Active Transportation Commission

Re: Freeport Boulevard Transportation Plan Final Draft

Approaching Blair Avenue from the south. Highway design encourages unsafe speeds.

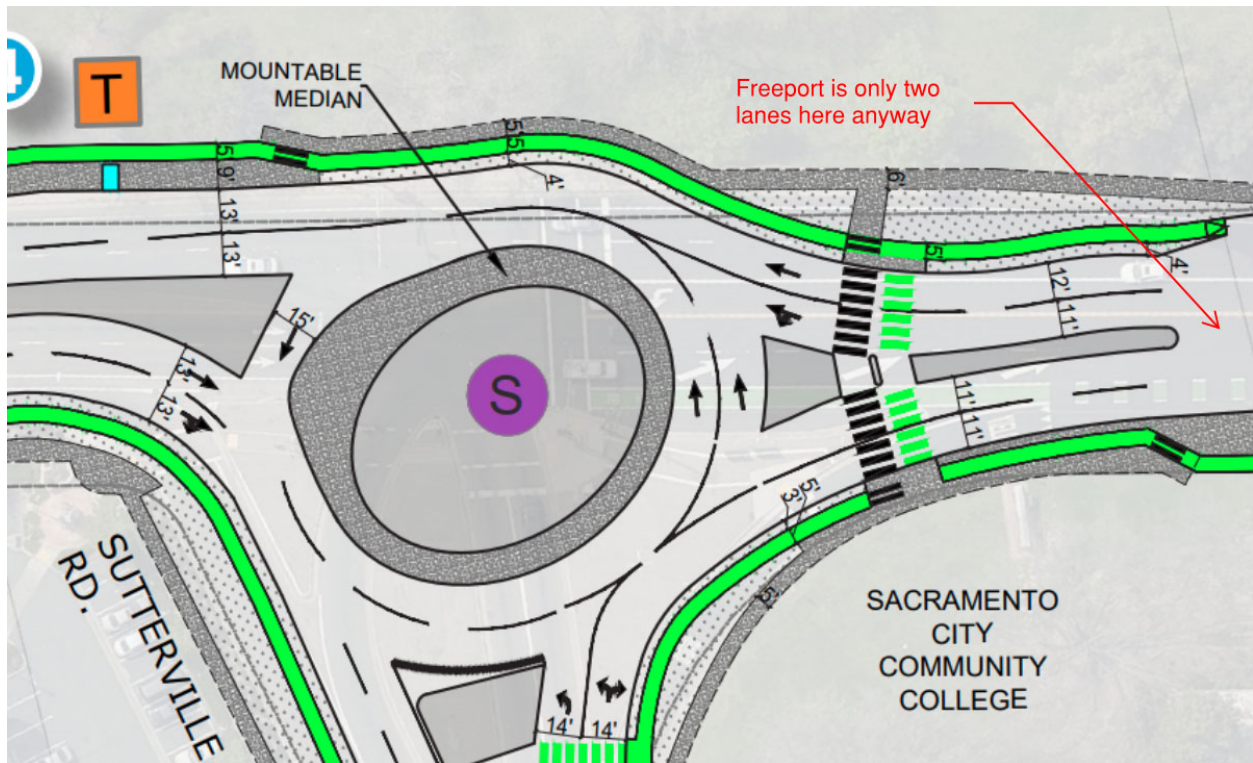
The Plan makes no mention or study of existing speed limits or notes on observed vehicle speeds. At the south end of the corridor, the speed limit is 50 miles per hour with highway designs. Vehicles tend to carry this speed north as they travel through the corridor, even as the speed limit incrementally decreases to 30 mph in the northern end of the corridor. These speeds limits are excessive and drivers tend to speed well beyond these posted limits. The design speed should be reduced to no more than 25 mph and the plan should propose additional strategies to reduce vehicle speeds such as raised intersections and pedestrian crossings. This should include a strategy to significantly and immediately reduce speeds at the southern gateway near the airport prior to Blair Ave, such as traffic tables, textured paving, and flashing signage.

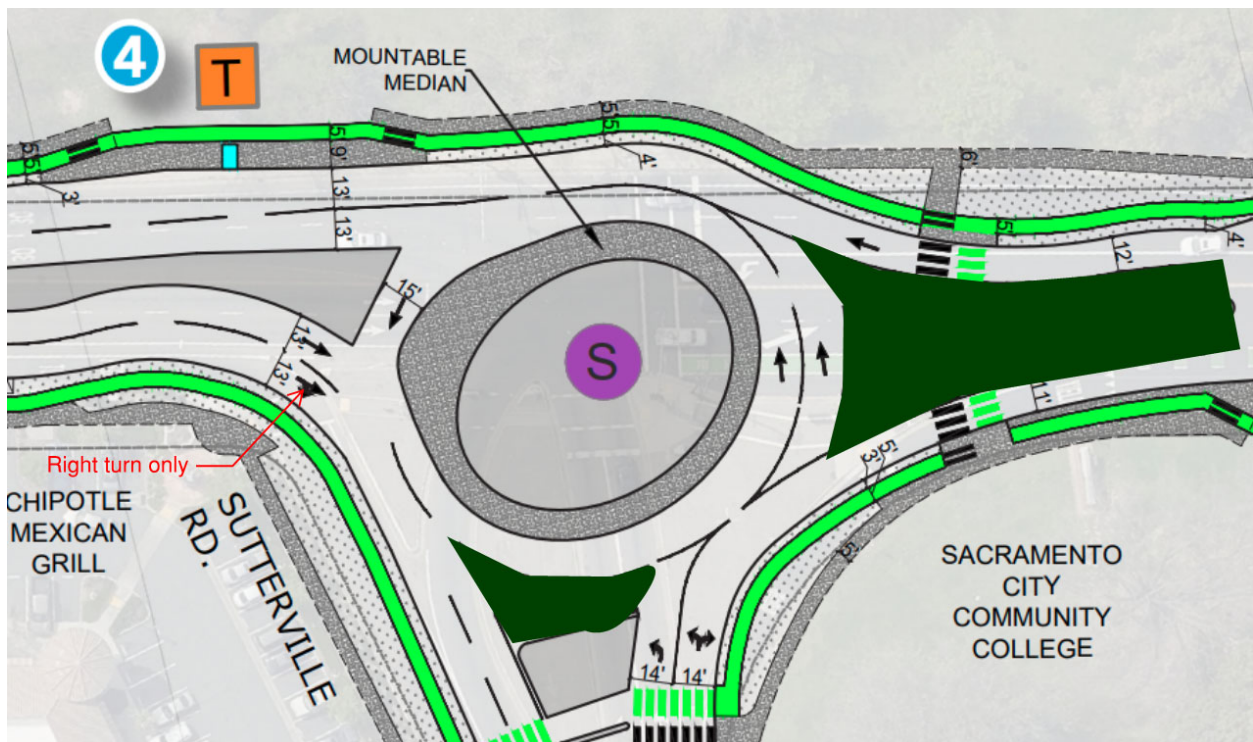
Especially egregious is north of the roundabout. The street immediately transitions to one lane in each direction after the roundabout, so its not even clear why two lanes is helpful from a traffic perspective. This increases the crossing distance by 22 unnecessary feet.

Existing Design:

Reduced design:

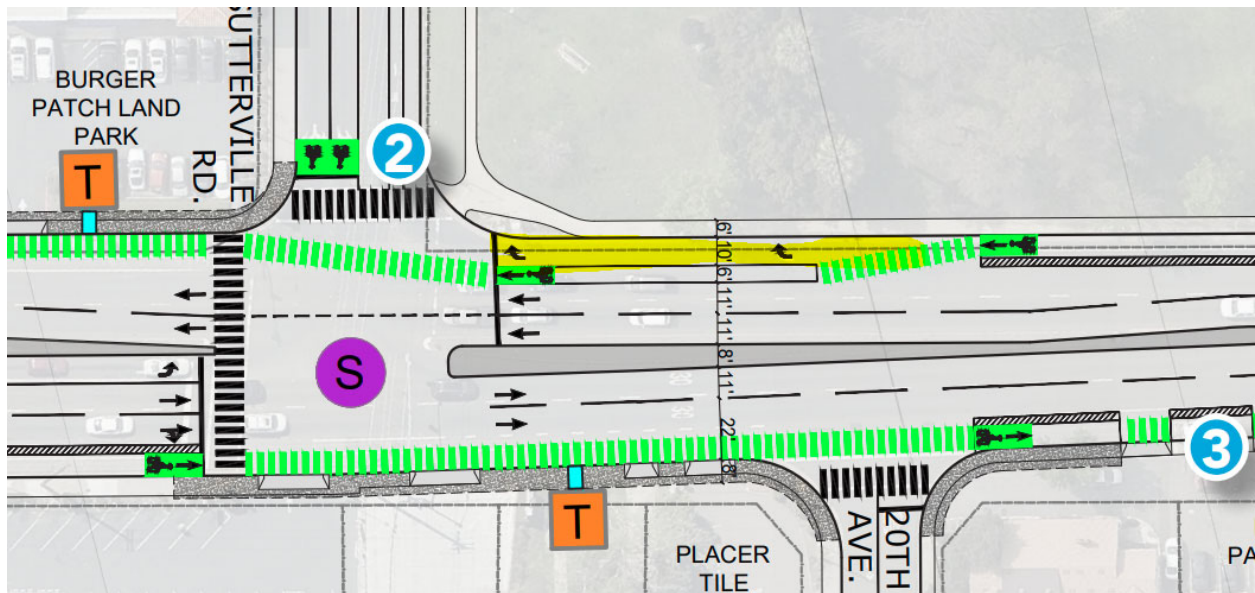
The proposed design for Freeport to Sutterville includes a dedicated right turn lane that is dangerous and will be high-stress for cyclists, dissuading most users from navigating the corridor. Why was this lane necessary? Is there an alternative that is more comfortable for cyclists?

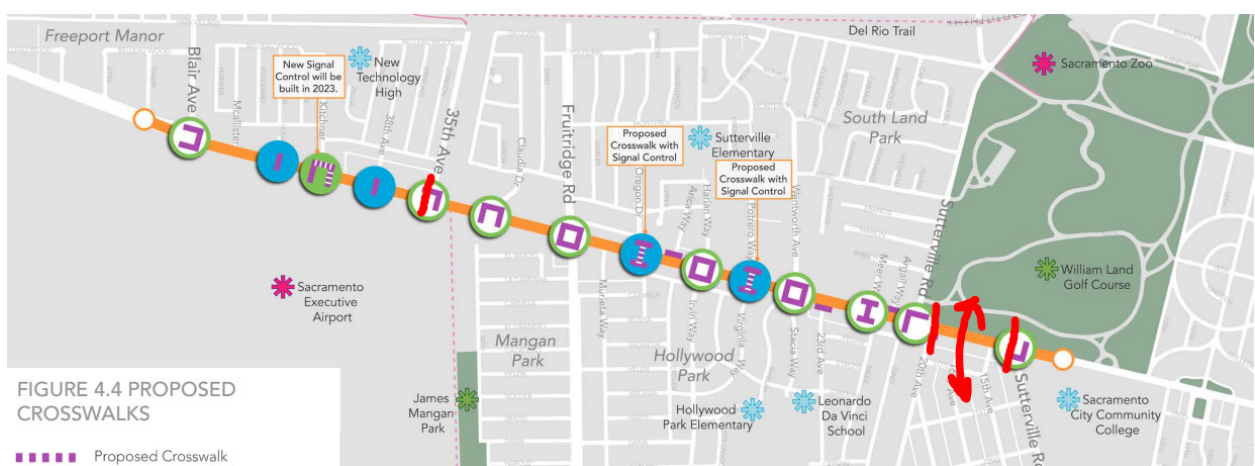
Many intersections continue to only provide one crosswalk on one side of the intersection. This is a clear indicator that a design remains automobile oriented, prioritizing turn movements over pedestrians. This includes the intersections at Sutterville Rd (North), Sutterville Rd (South), and 35th Avenue.

This is most concerning for residents of the Carleton Tract, who have to cross not one but two major streets just to reach their closest greenspace. Carleton Tract residents should have quick, safe, convenient access this neighborhood gem.

6. Fruitridge/Freeport Intersection

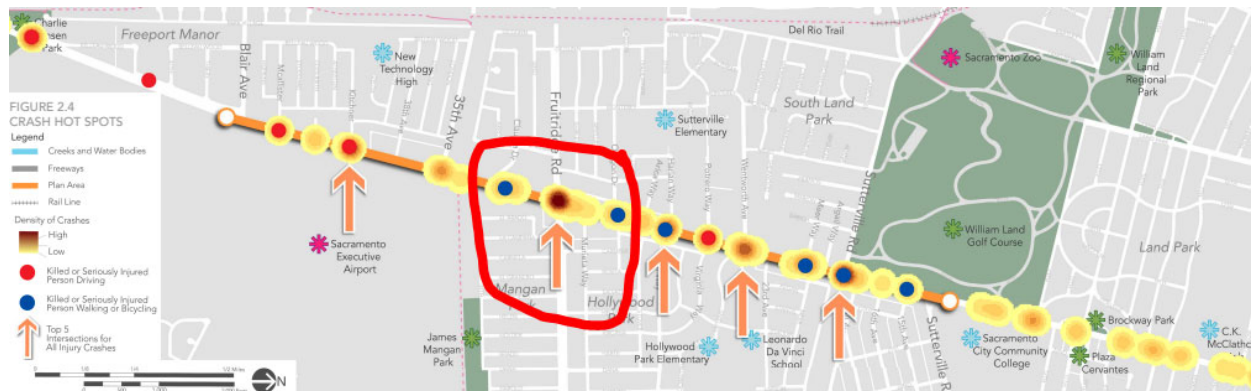
The Plan makes no mention of improvements to the Fruitridge/Freeport intersection, in spite of the fact that this was identified as the point with the highest density of crashes in the corridor. The intersection is also obscenely wide (7 traffic lanes). Is there a plan to reduce the number of lanes through this intersection?
